Re: **Request for Access to Records under the Freedom of Information and Protection of Privacy Act (the "Act")**

**Subject:** RE: BSCGP - South Granville Stage 1 Piling - Revision B (e-amil 3 of 3)

Document Title: Comment Resolution Sheet for South Granville Stage 1 - Traffic Signal & Street Lighting Design

SOUTH GRANVILLE STATION  
TRAFFIC CONTROL STAGE 1  
WEST BROADWAY TRAFFIC SIGNAL &  
STREET LIGHTING PLAN (1 OF 2)  
DRAWING NUMBER  
BSP-71006-SGIG-41DD-1xxx

SOUTH GRANVILLE STATION  
TRAFFIC CONTROL STAGE 1  
HEMLOCK STREET AT WEST BROADWAY  
TRAFFIC SIGNAL PLAN (1 OF 1)  
DRAWING NUMBER  
BSP-71006-SGIG-41DD-1xxx

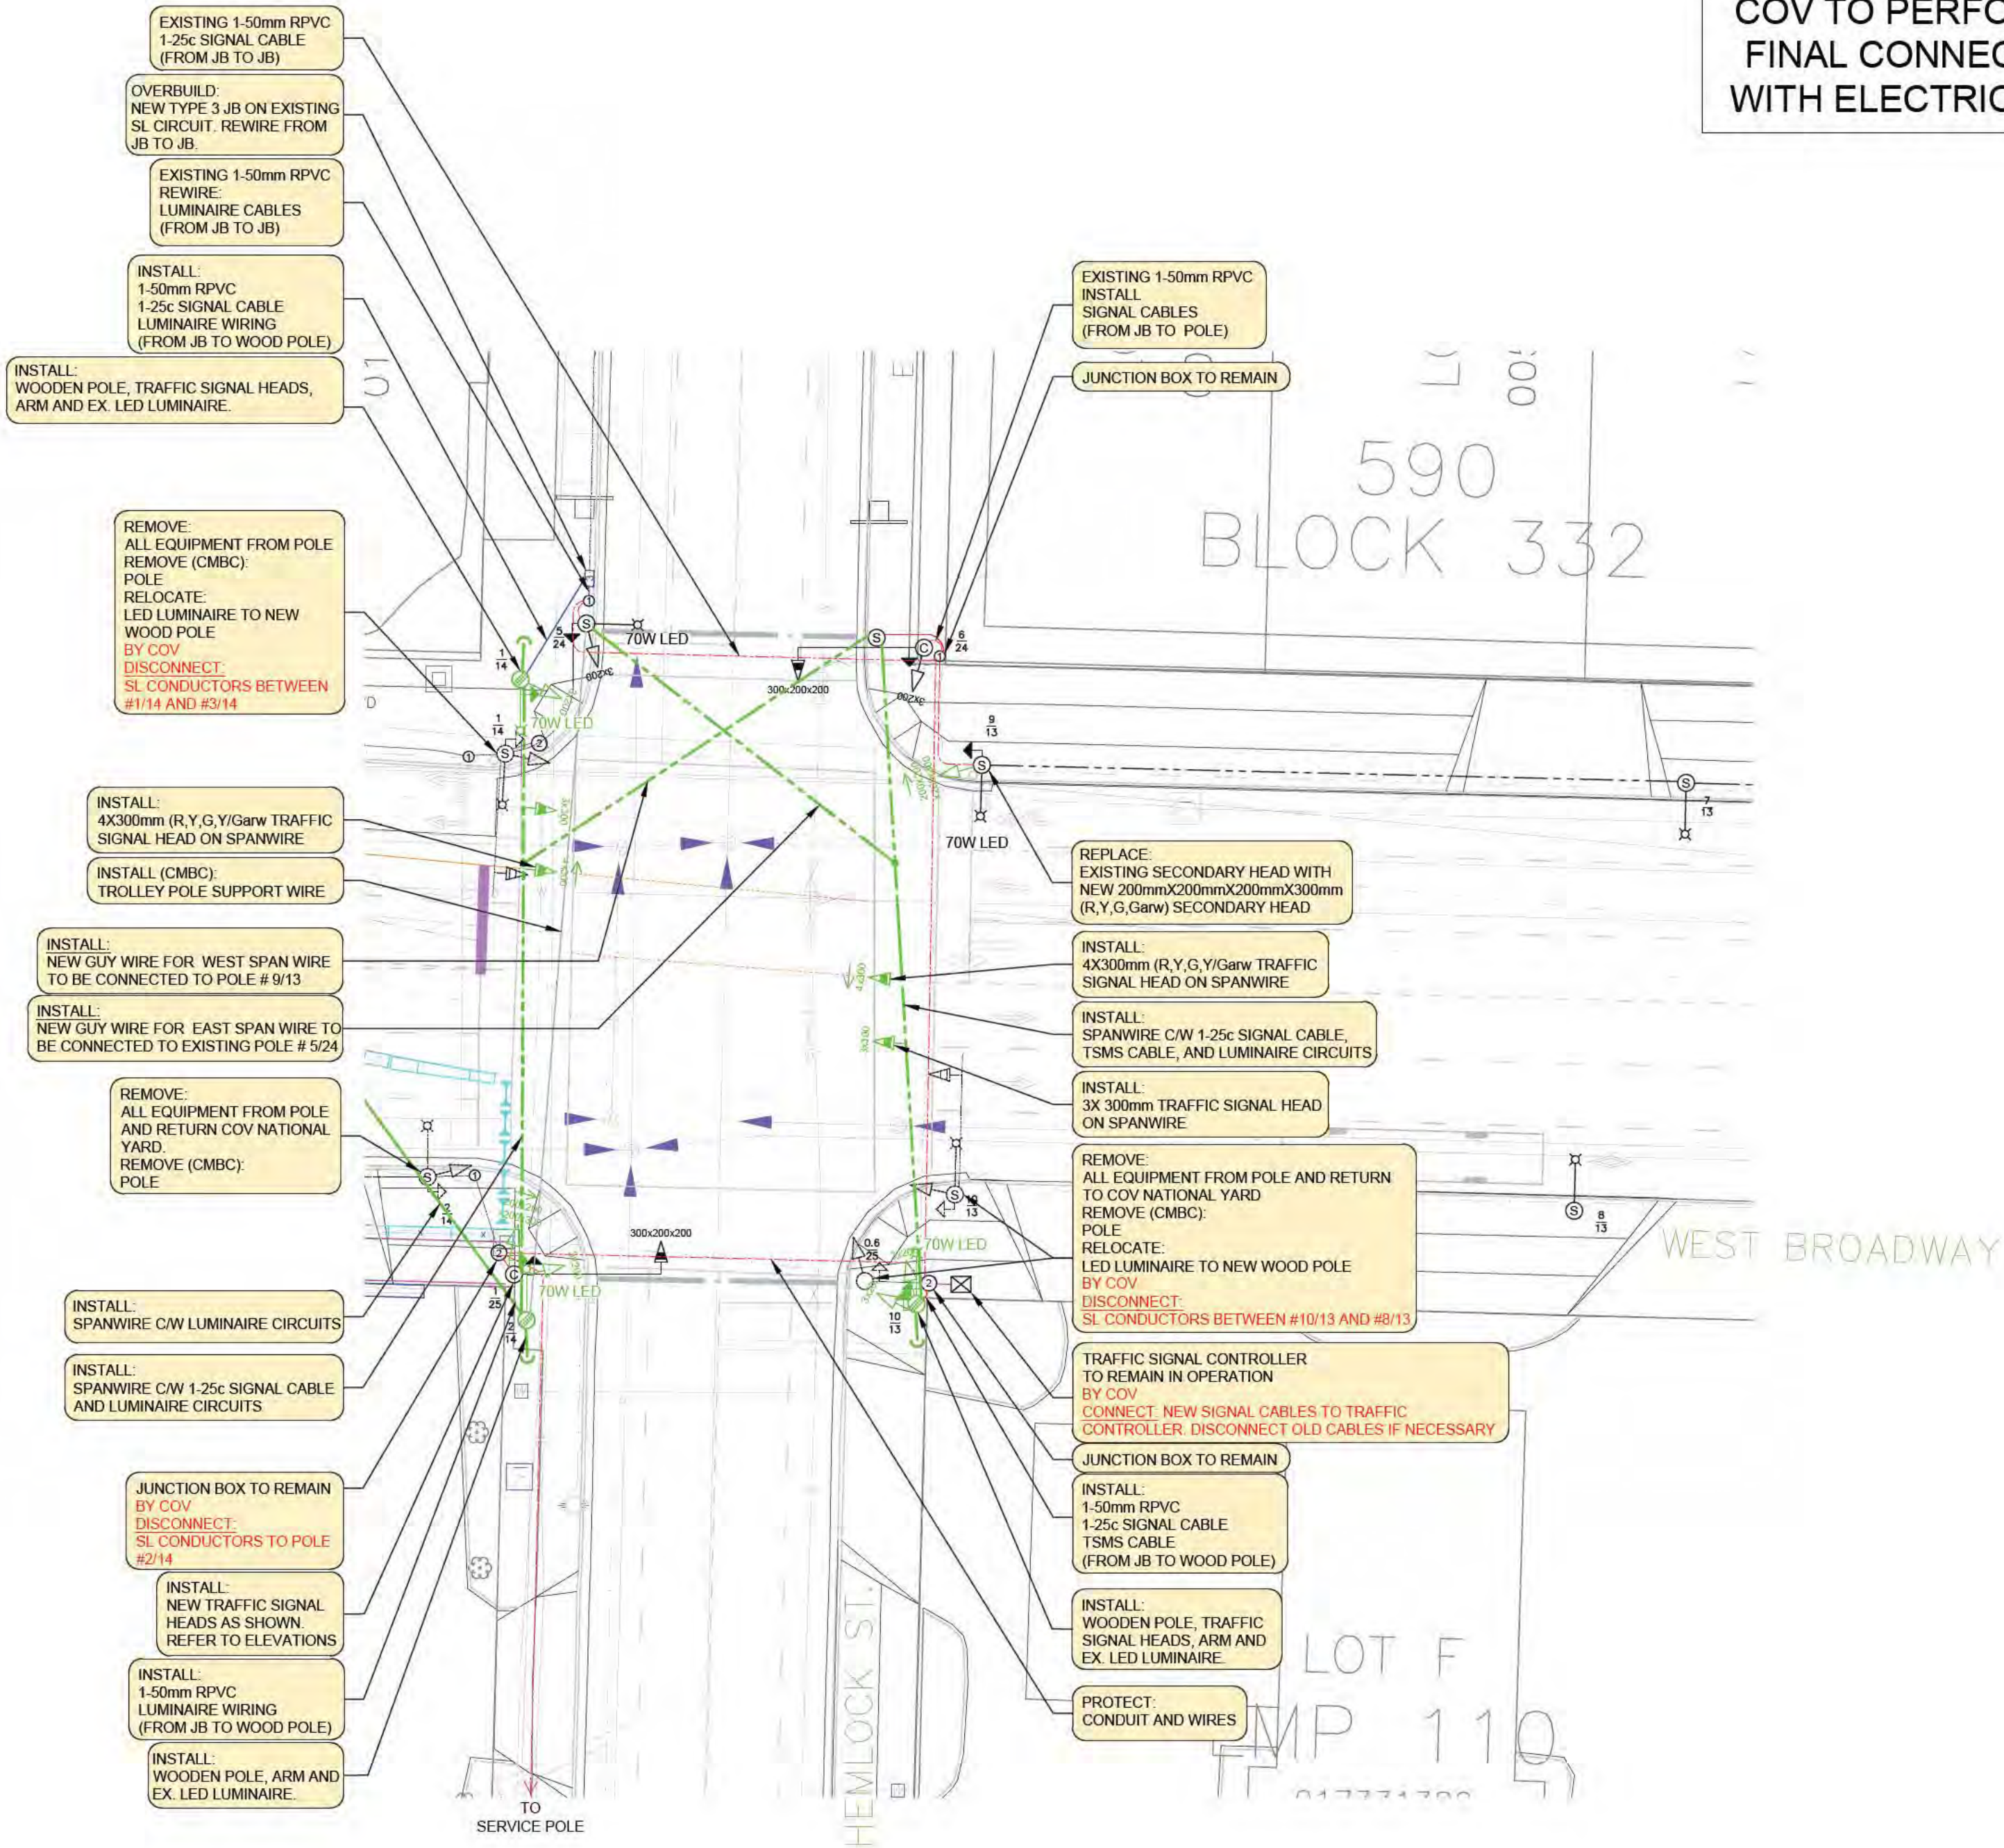
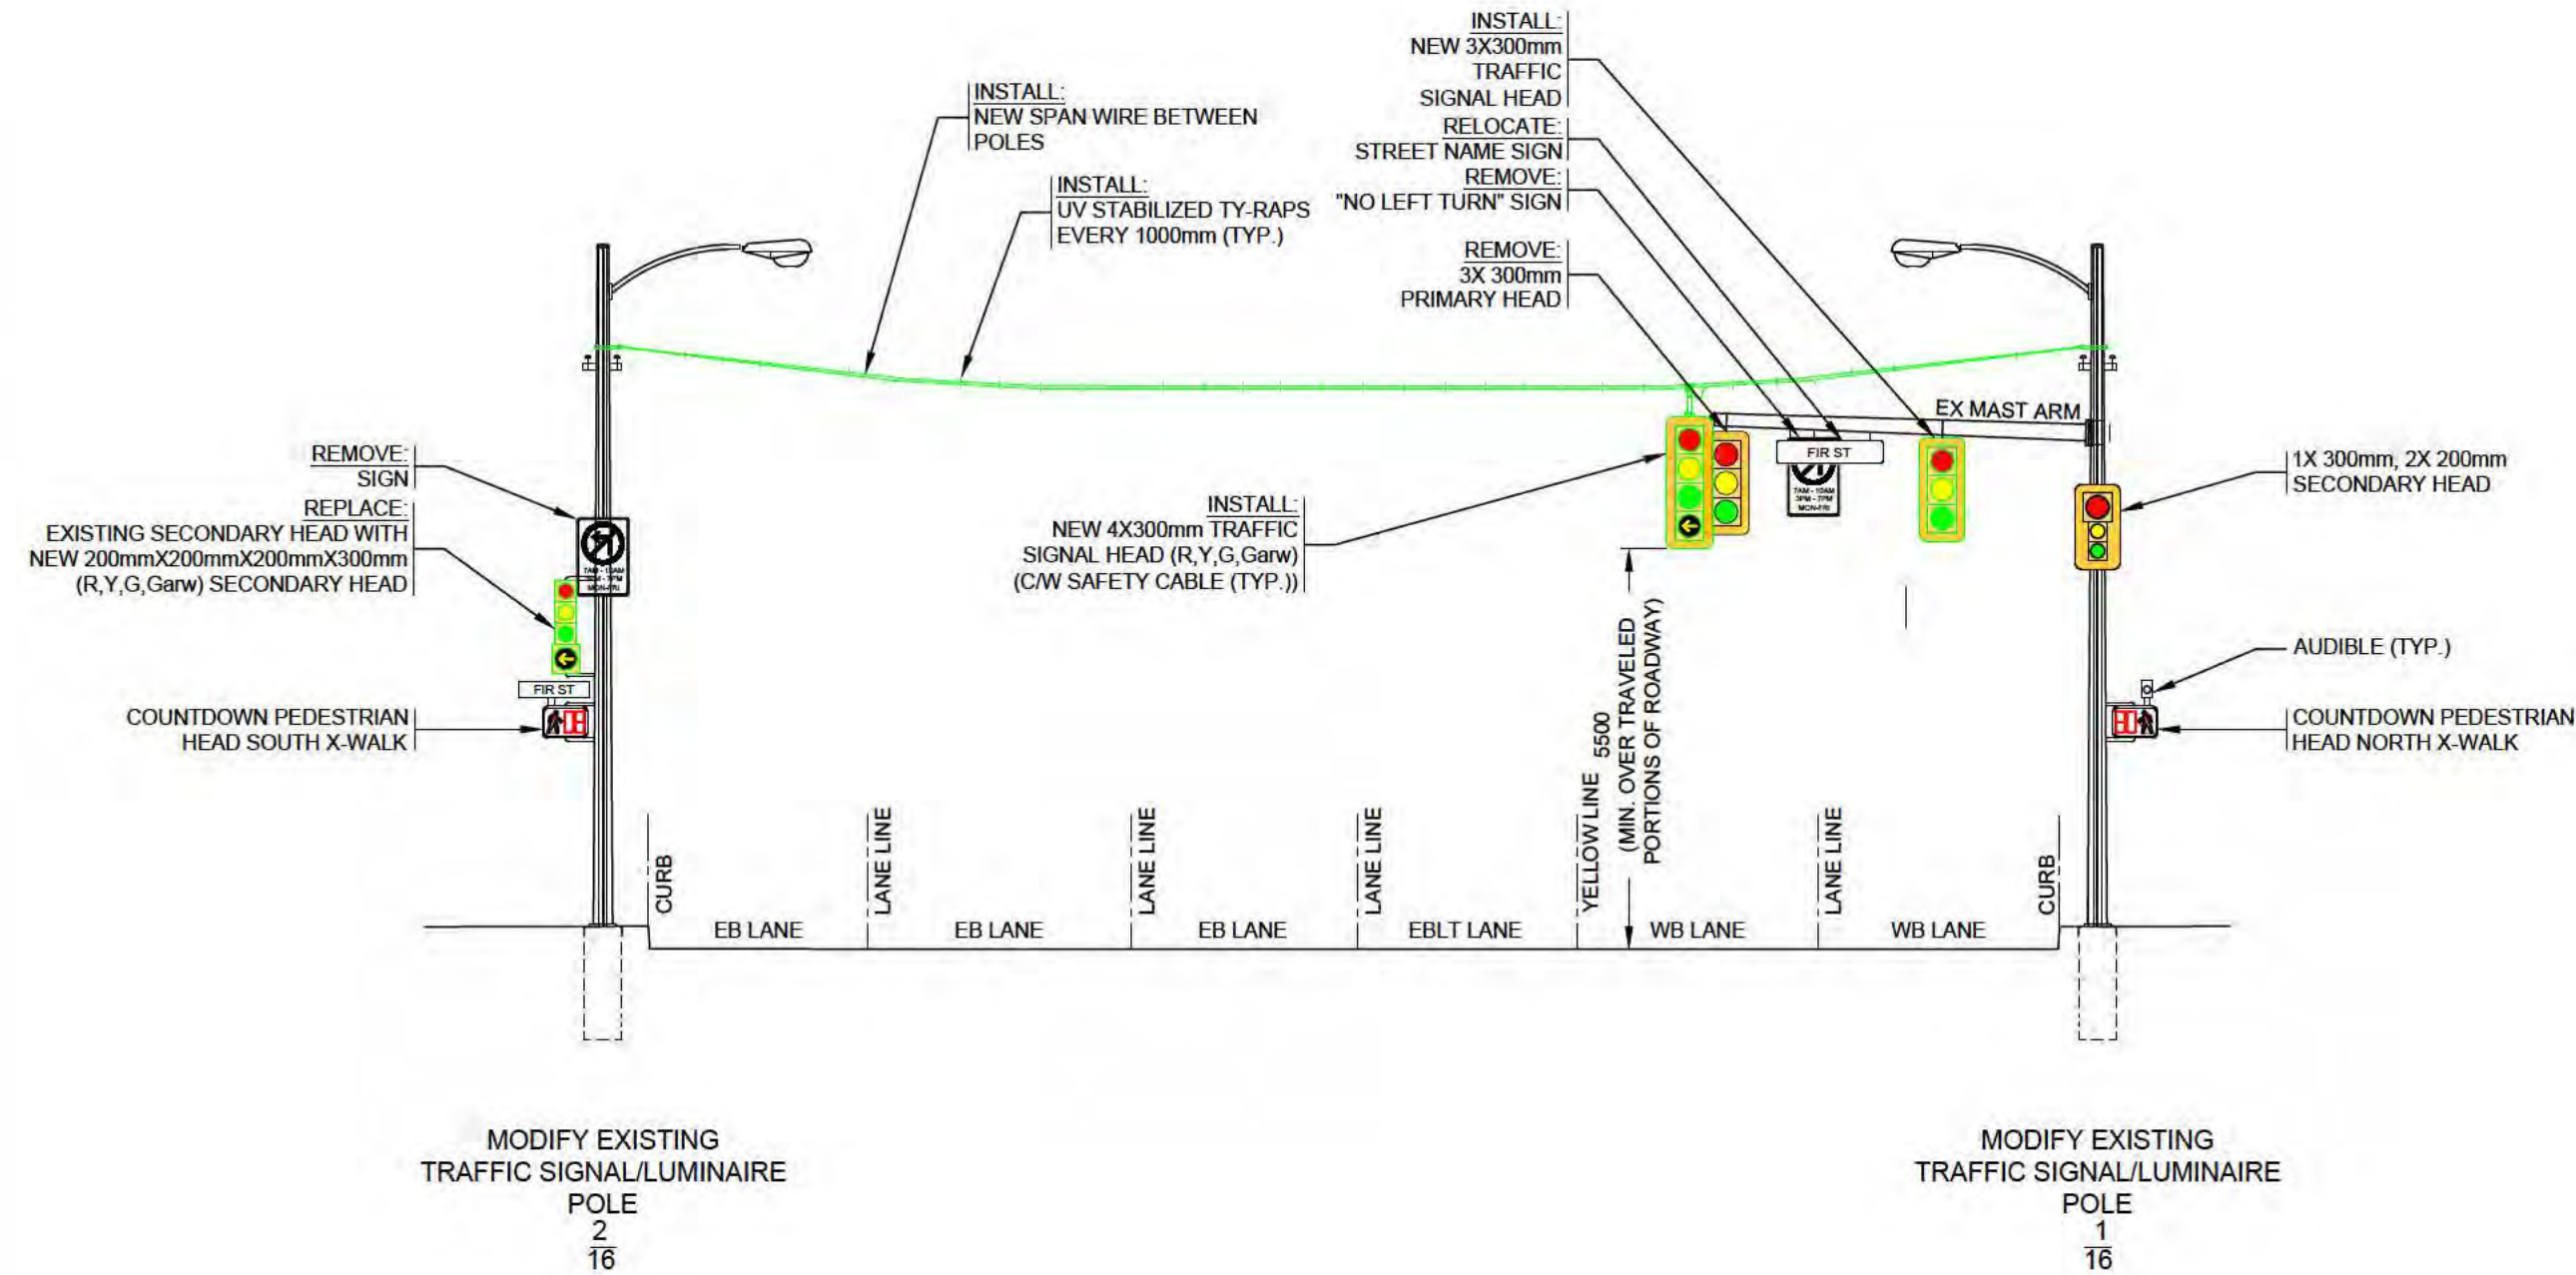
TRAFFIC SIGNAL & STREET LIGHTING DESIGN - PAGE 5		24	TDM	base plan doesn't match either of the hemlock geometric options. Update based on final option decision TDM will review in full again once updated	Correct	AR	<a href="#">Base plan was updated with latest civil</a>	Closed
